Redwood Miamisburg North Springboro Pike OH P1 Construction Site Plan

BUILDING C

OVERALL FLOOR PLANS - BLDGS.: C, D

REDWOOD MIAMISBURG

Meadowood Left PVC

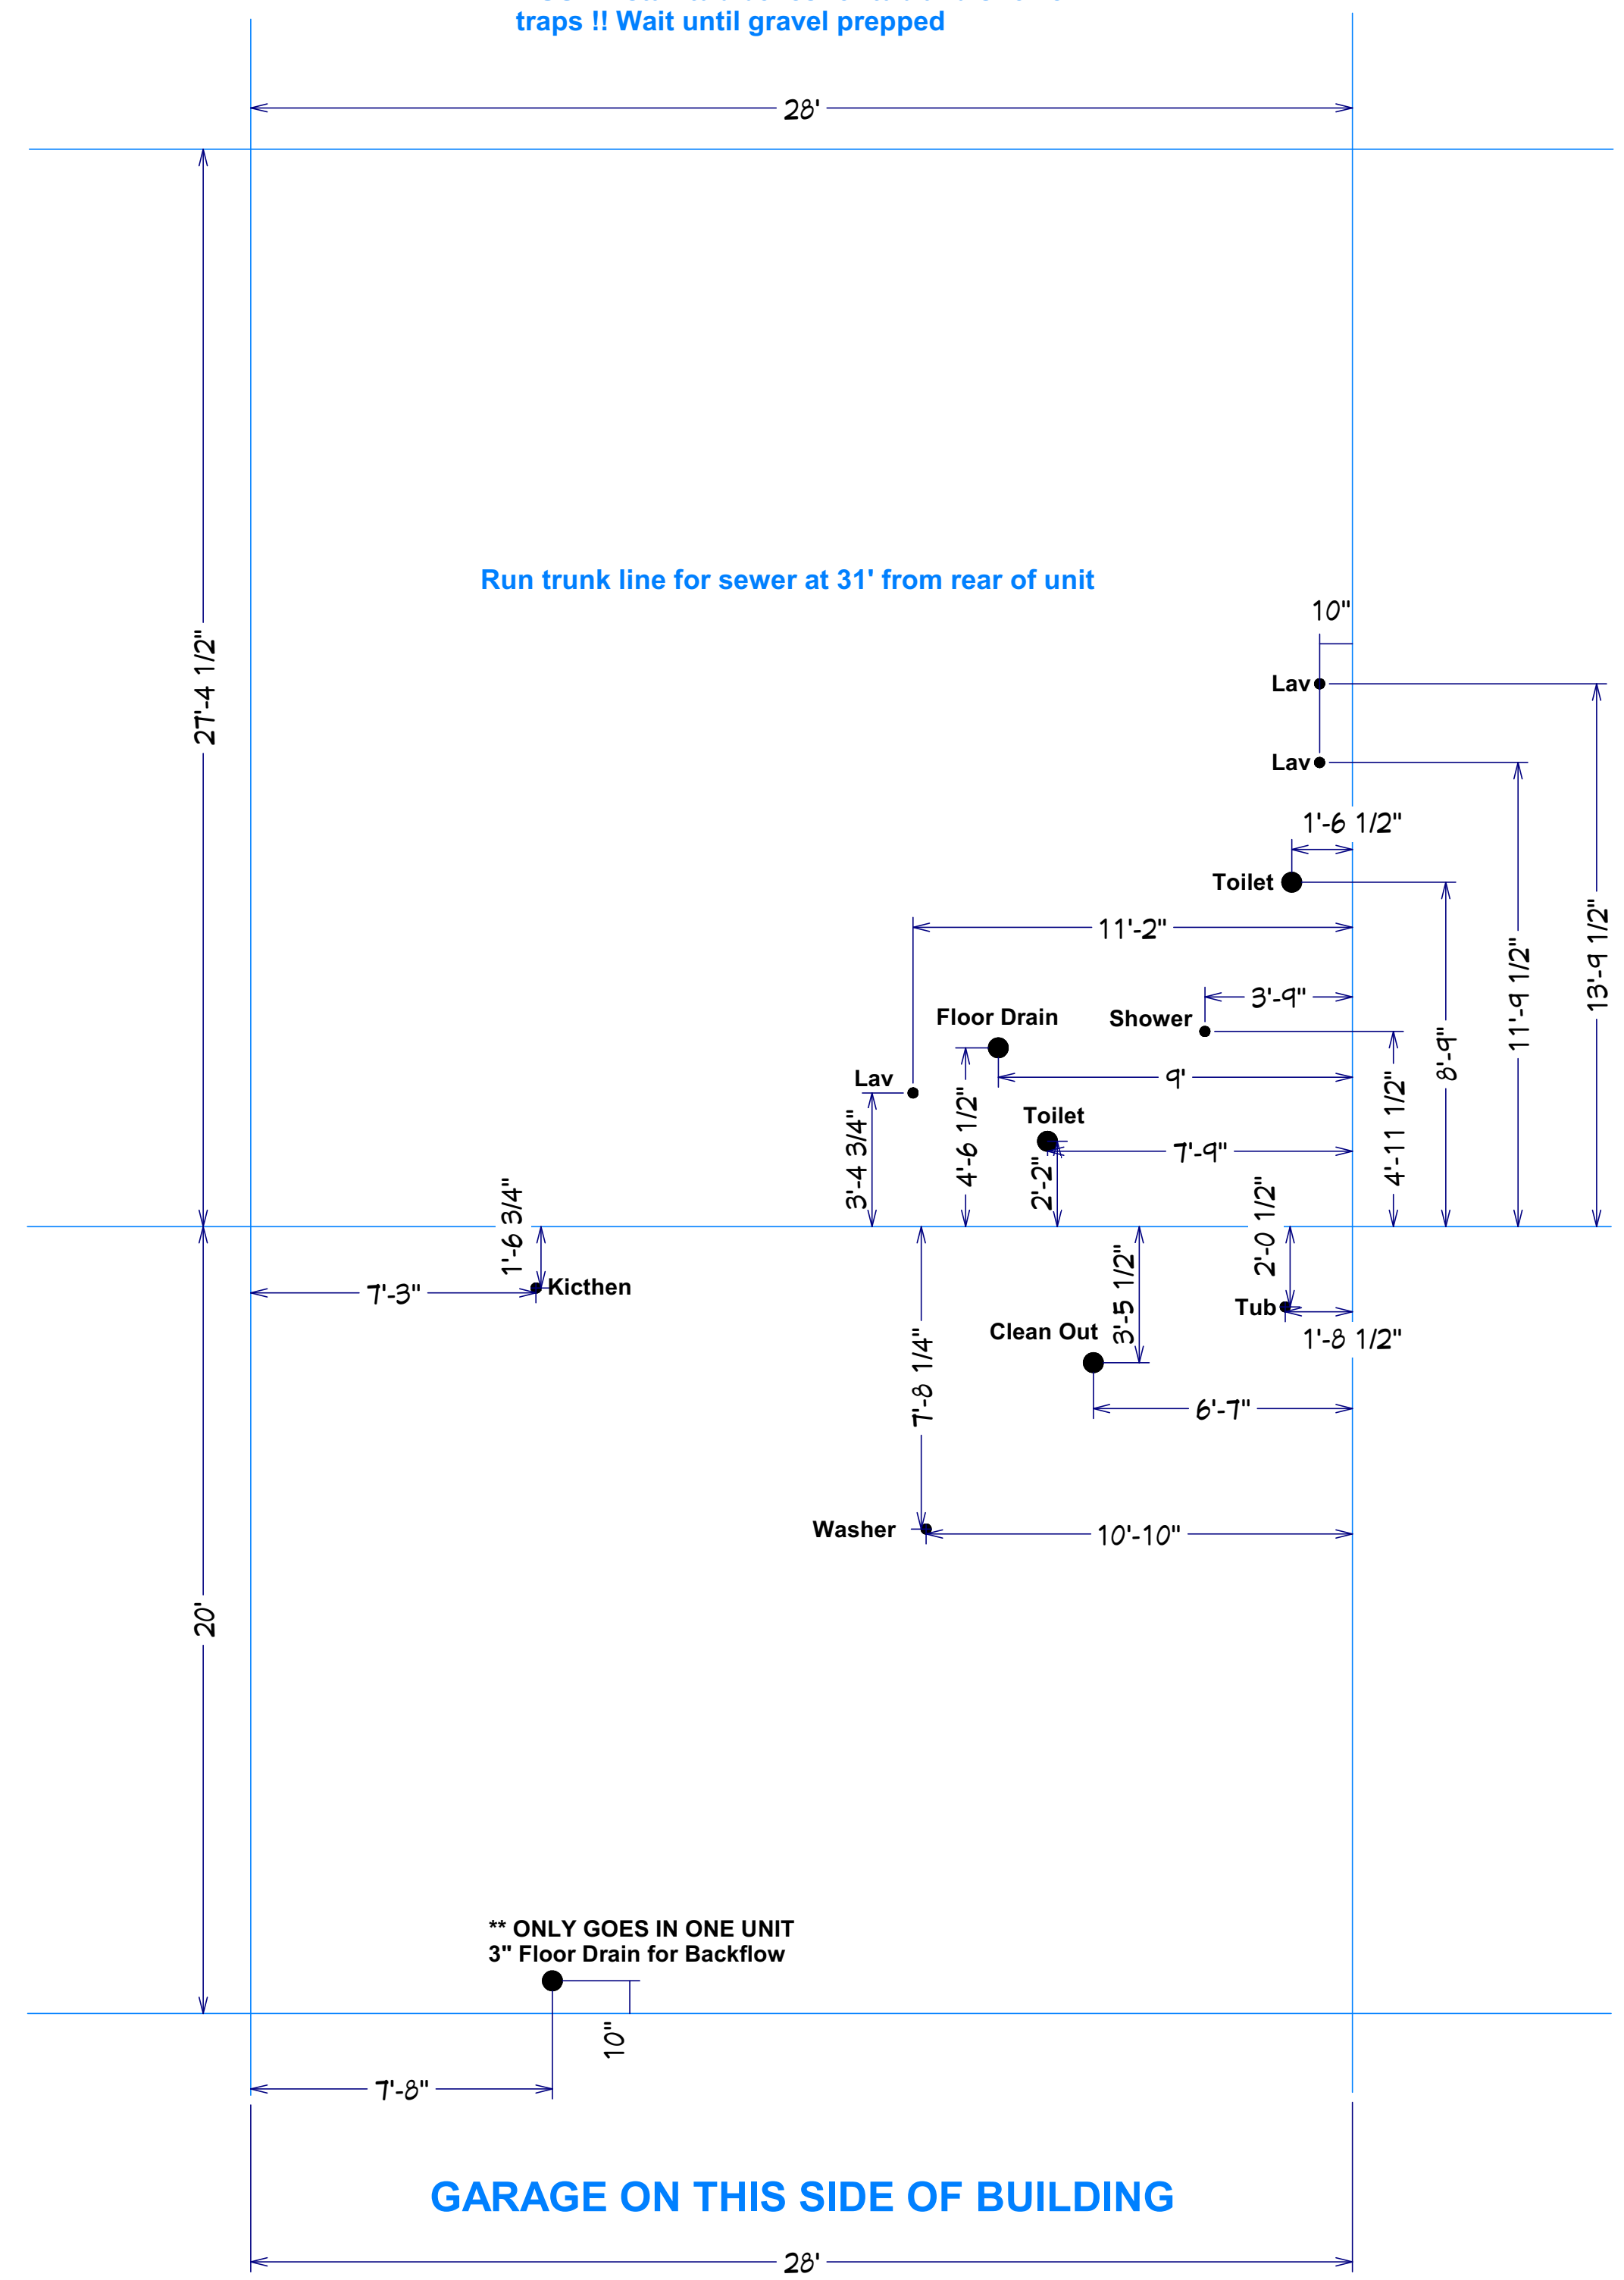
MUST install tub boxes for tub and shower traps !! Wait until gravel prepped

Meadowood Right PVC

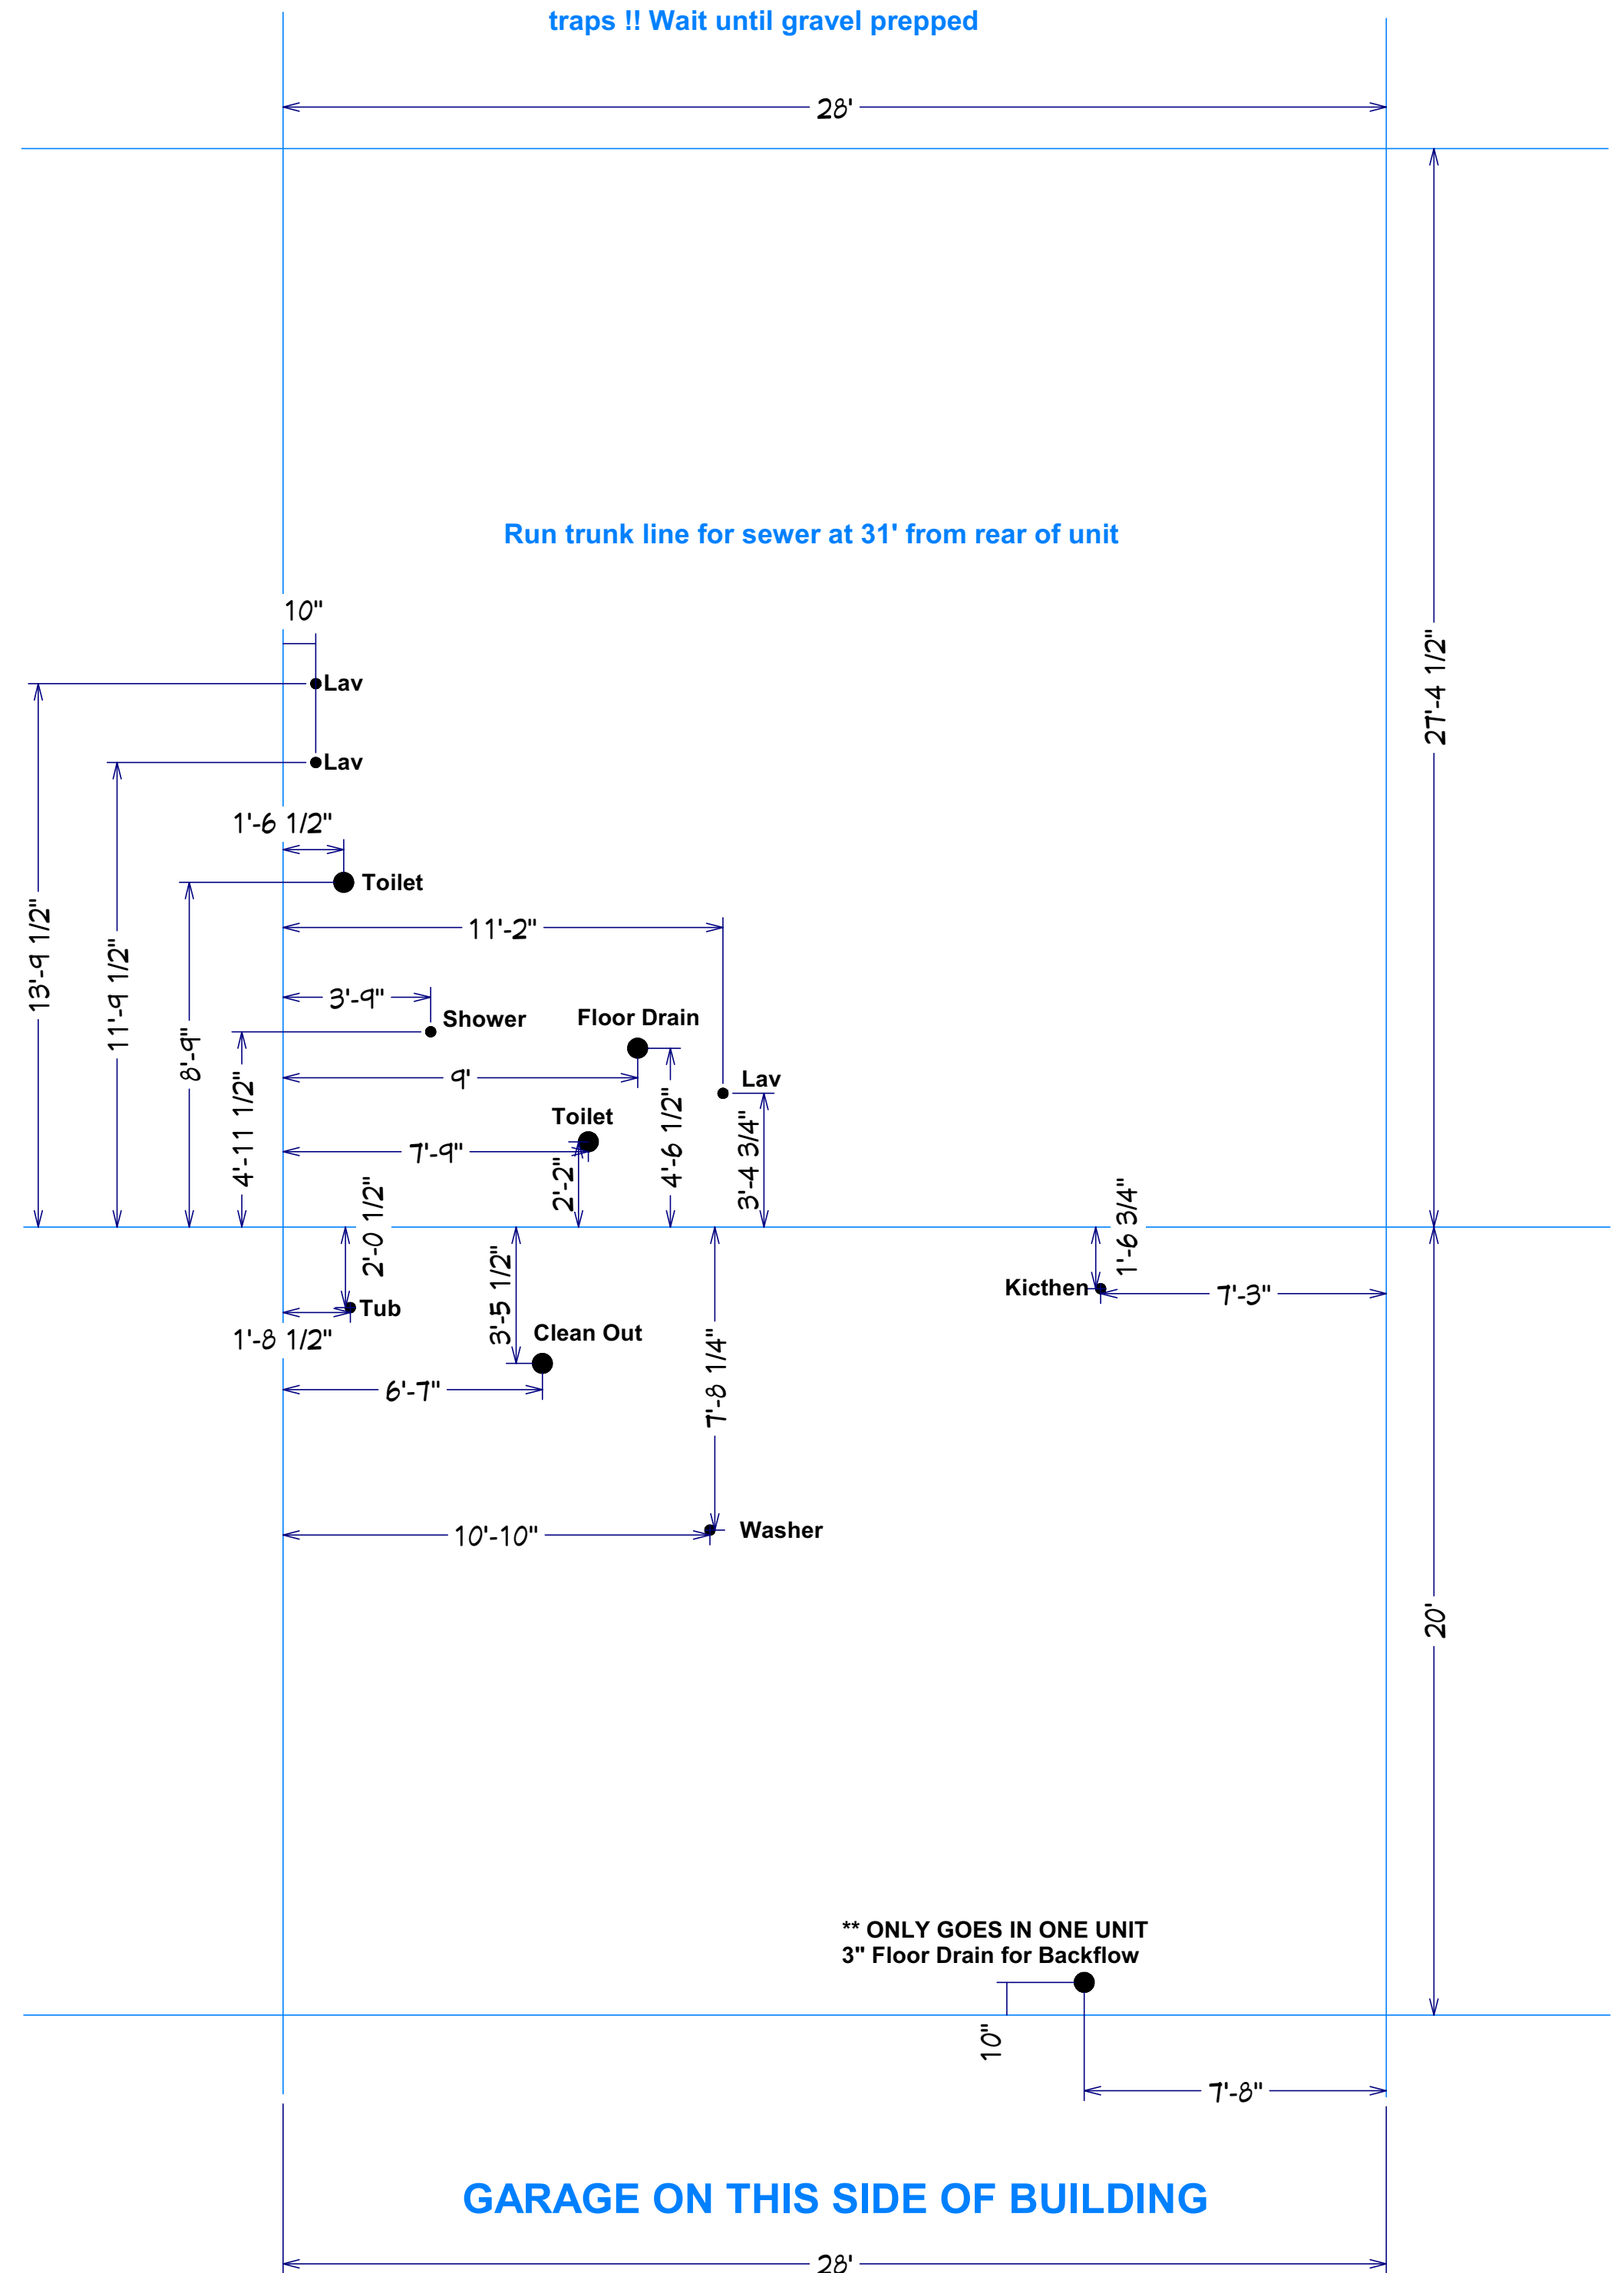
MUST install tub boxes for tub and shower traps !! Wait until gravel prepped

Run trunk line for sewer at 31' from rear of unit

**** ONLY GOES IN ONE UNIT
3\"/>**

Forestwood Left PVC

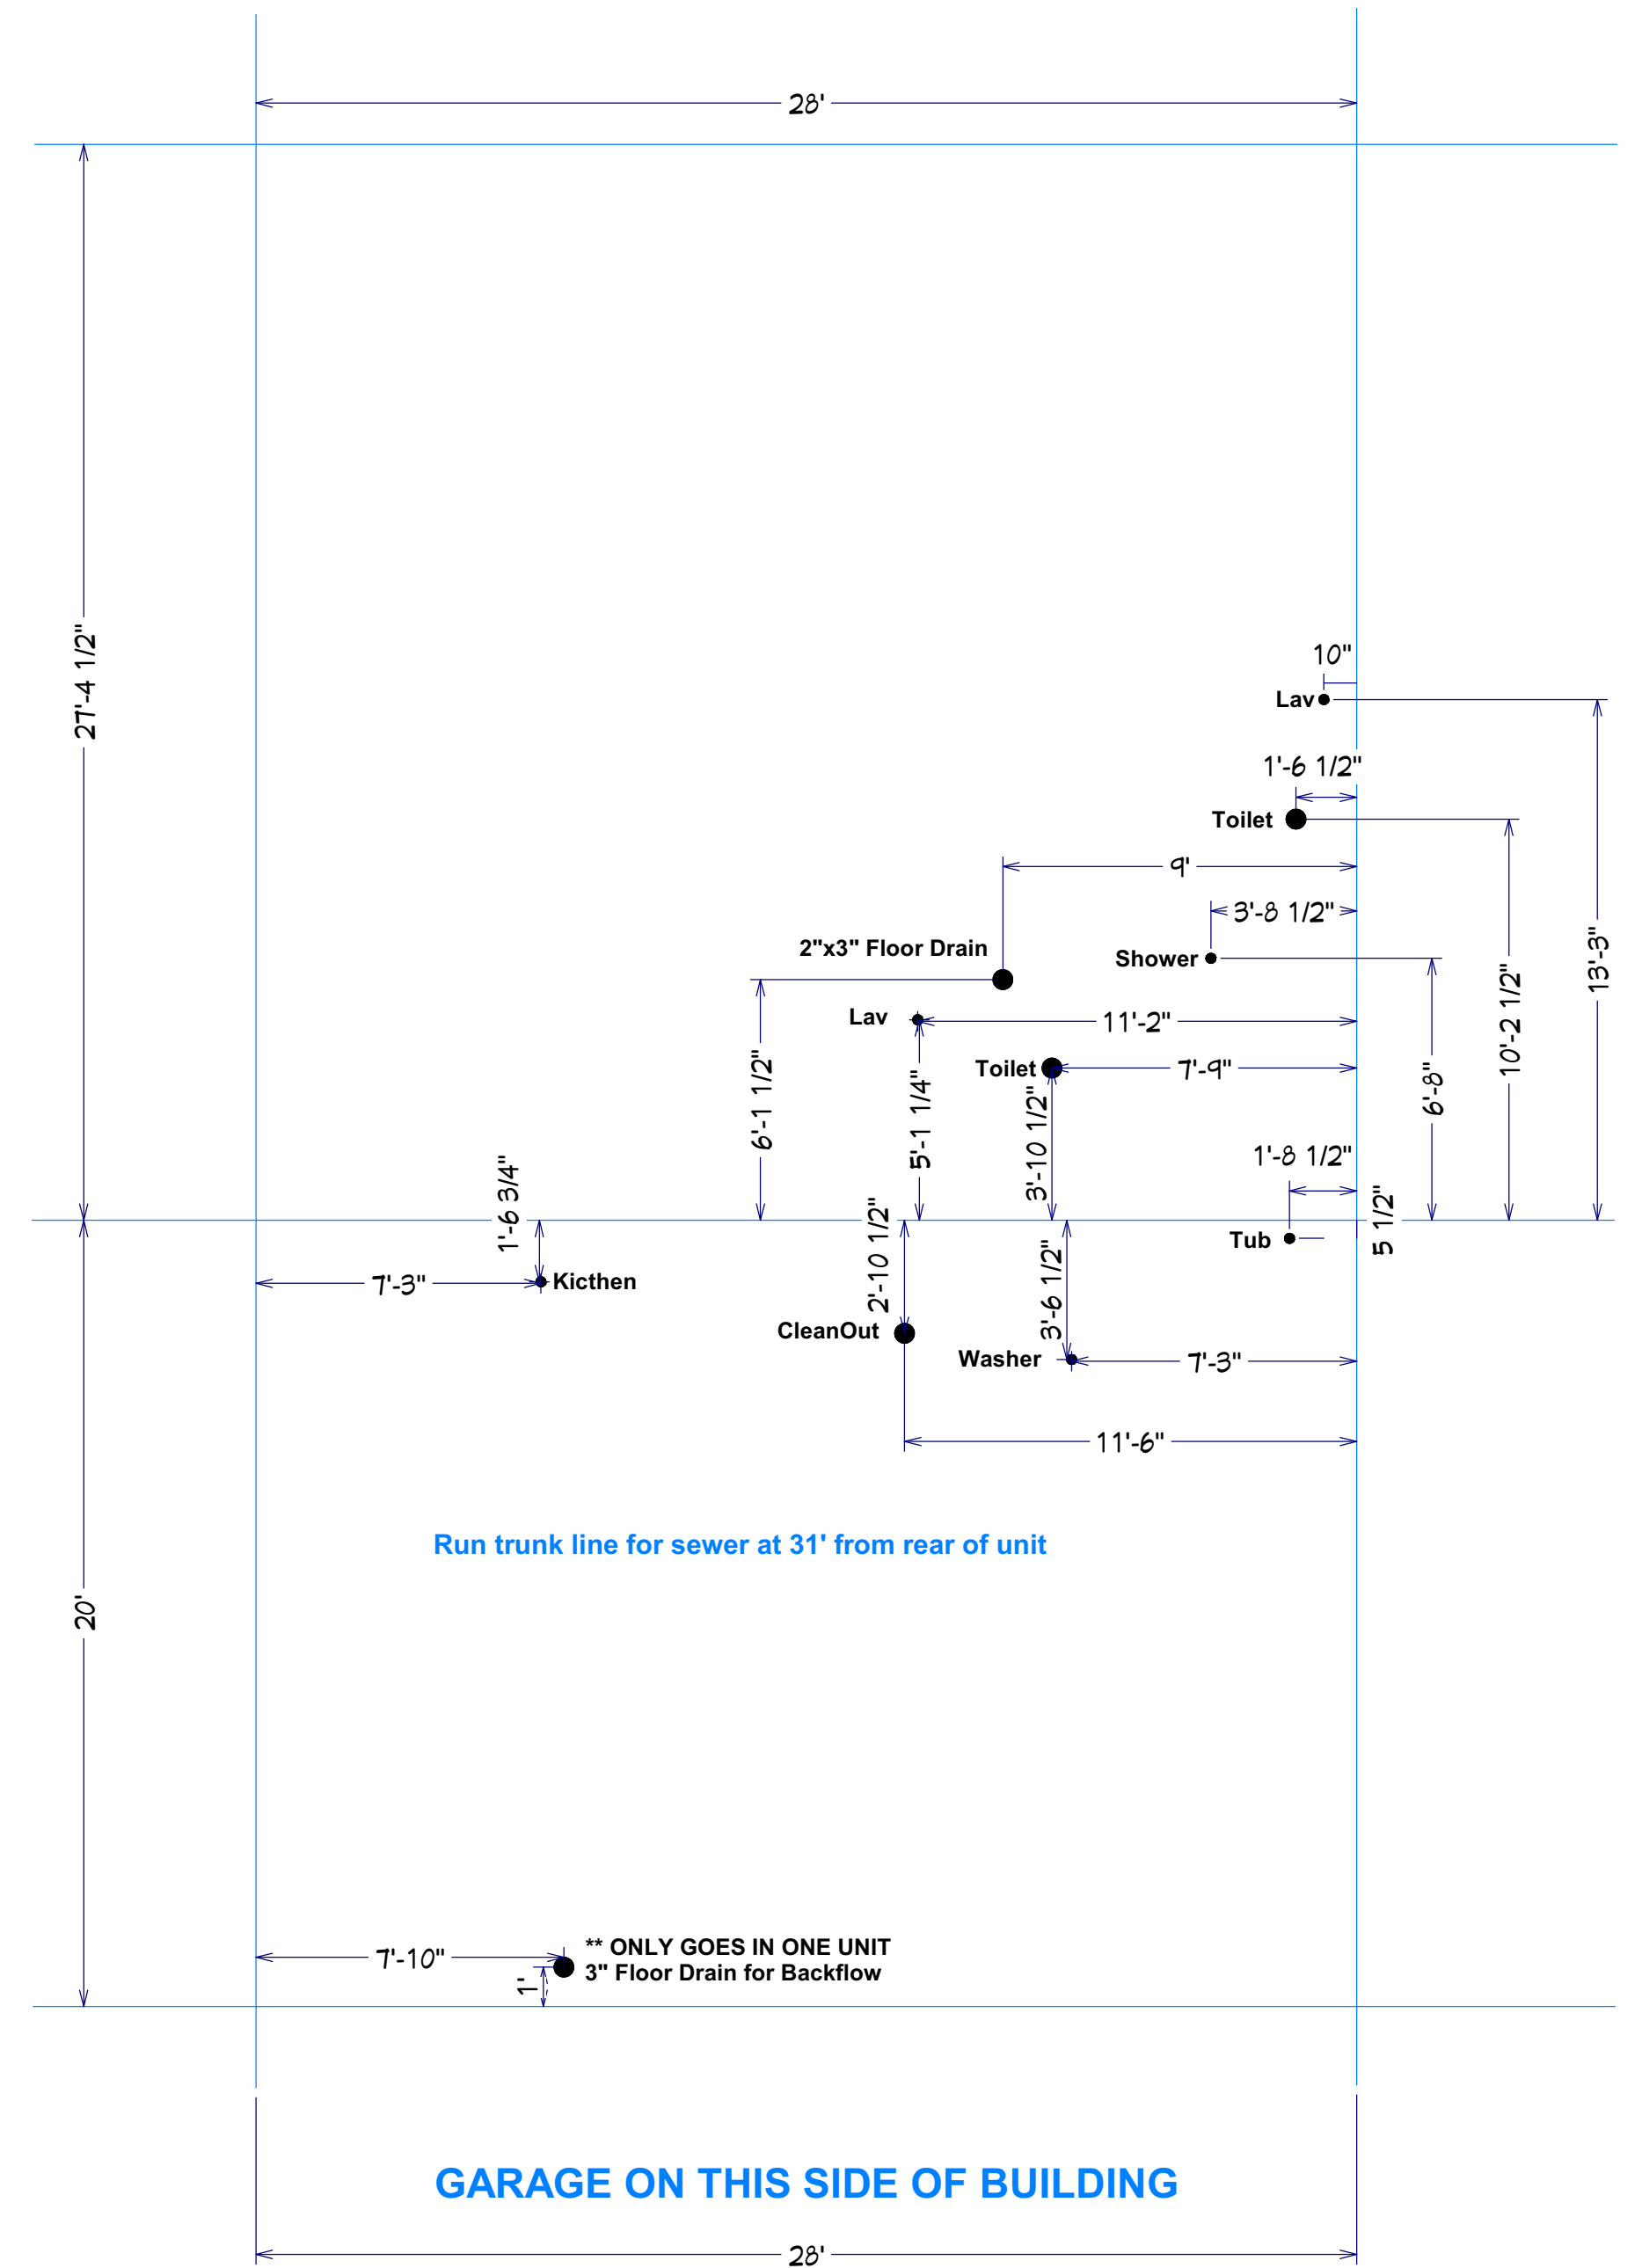
MUST install tub boxes for tub and shower traps !! Wait until gravel prepped

Run trunk line for sewer at 31' from rear of unit
